Re: Aquifer and Well Performance
Seminole Manor Wells

AQUIFER AND WELL PERFORMANCE TEST

SEMINOLE MANOR WATER PLANT

APT ANALYSIS

.01 PLATE III 0.1

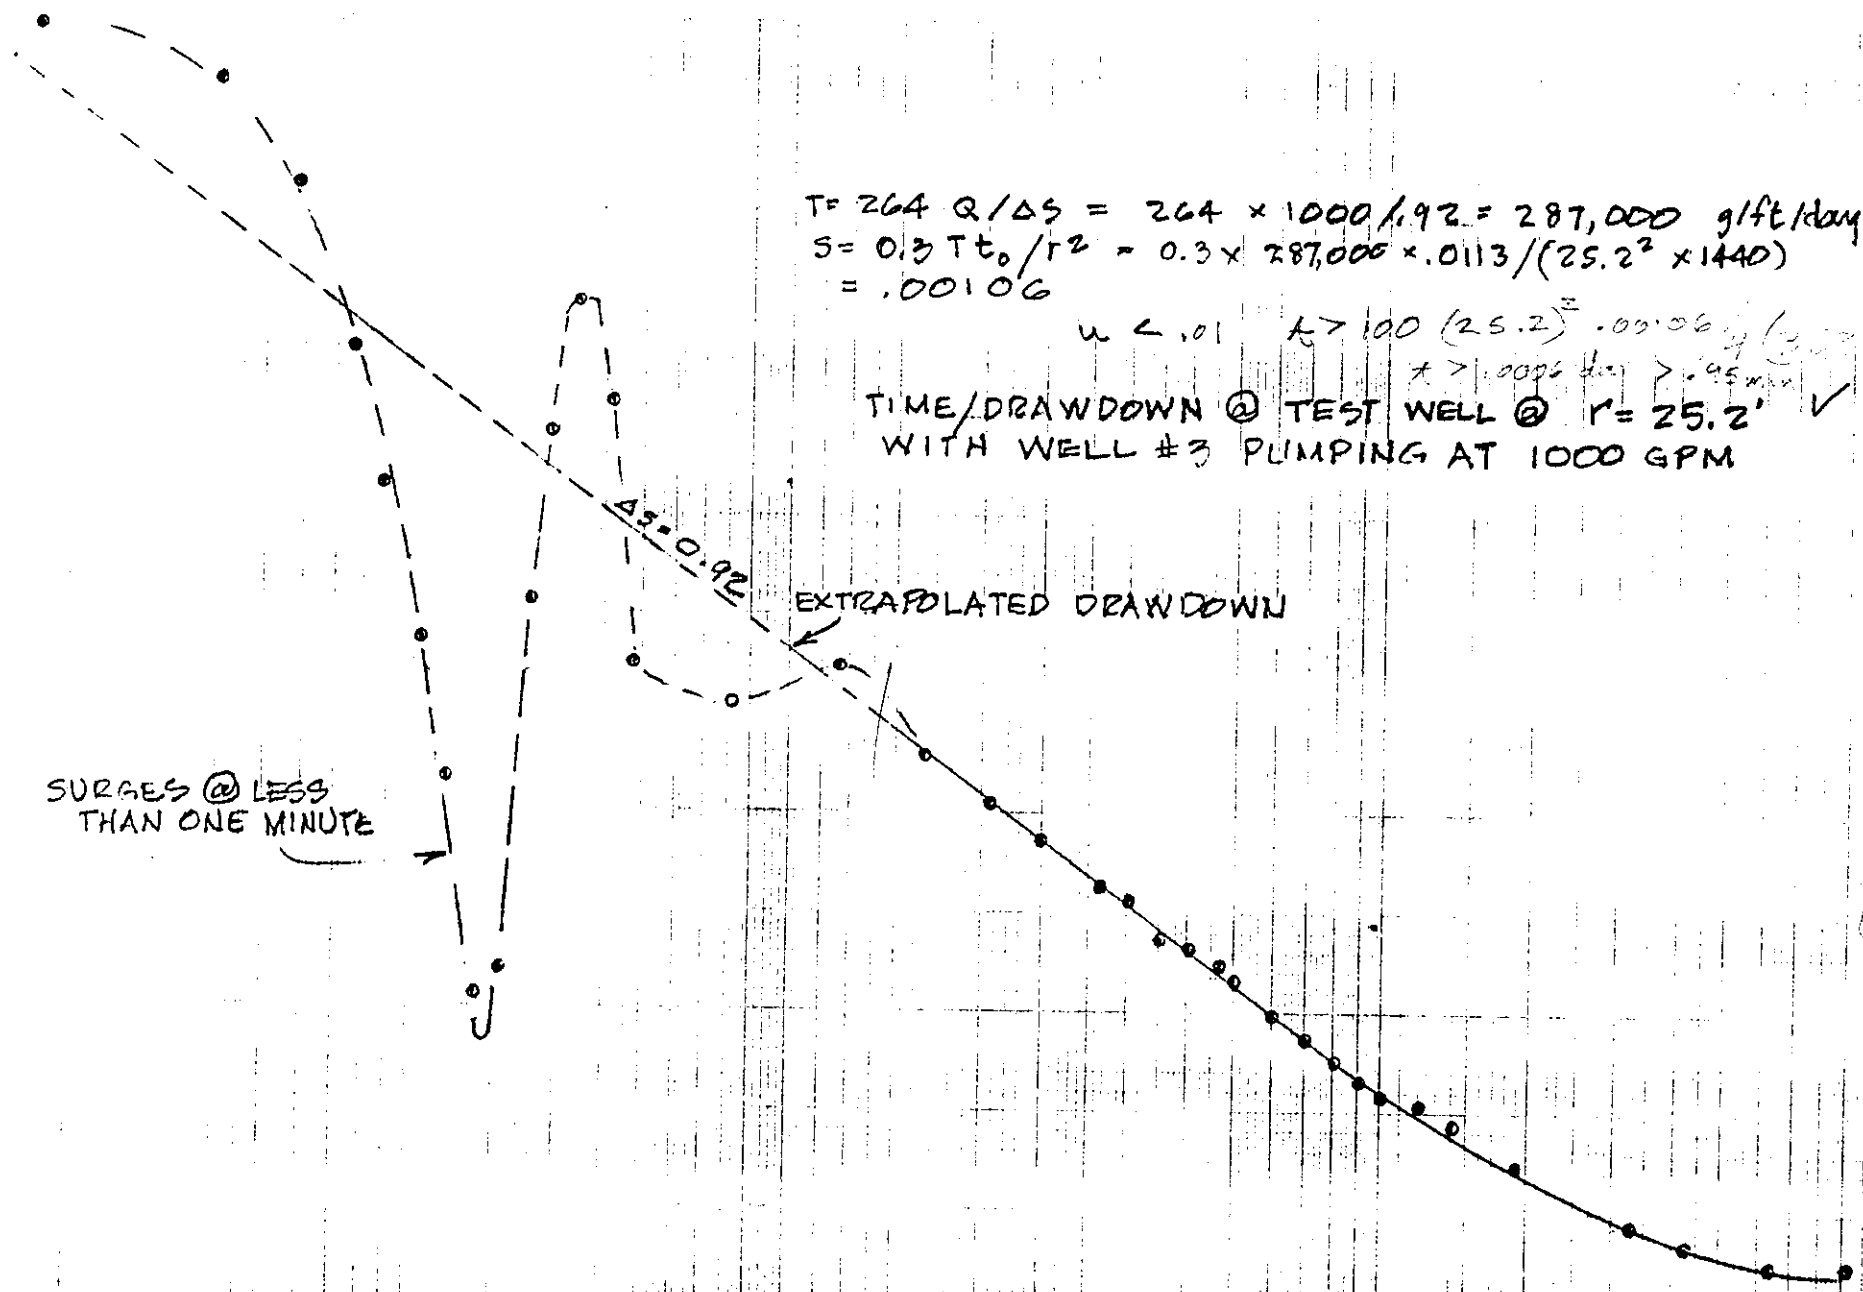
1) Major fluctuations present in all data points earlier than one minute.

2) Pretty good straight line approximation is/was possible.

3) From straight line extrapolation, consultant chose values for early time data points to be used in curve matching analysis.

Don't USE!!

see comment #3 above

1) Curve matching techniques are not reliable for this data if the points plotted earlier than 1 min are eliminated.

PLATE IV

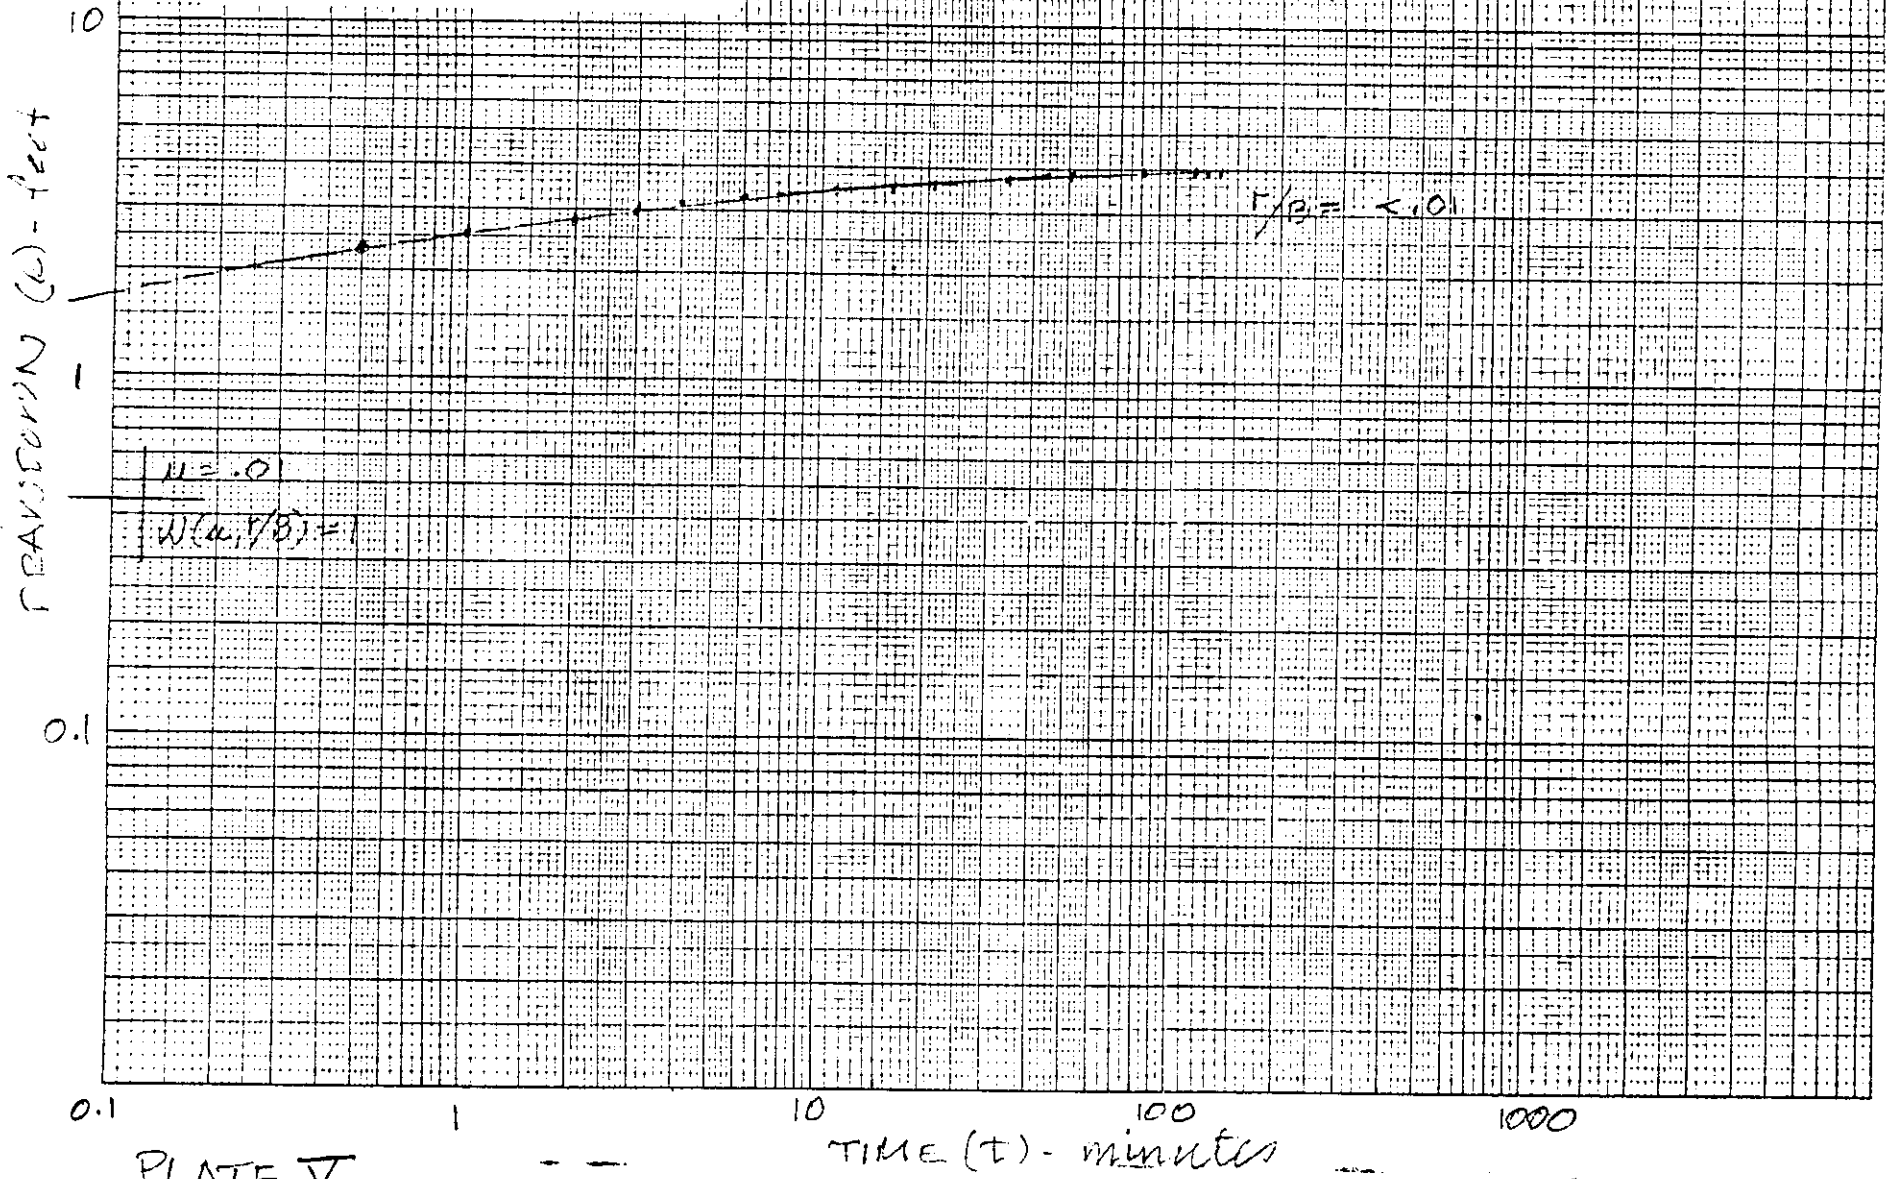
- 1) Difficult curve match due to lack of data earlier than .5 minutes
- 2) Could have potential for Jacob analysis
- 3) Well loss not considered in analysis
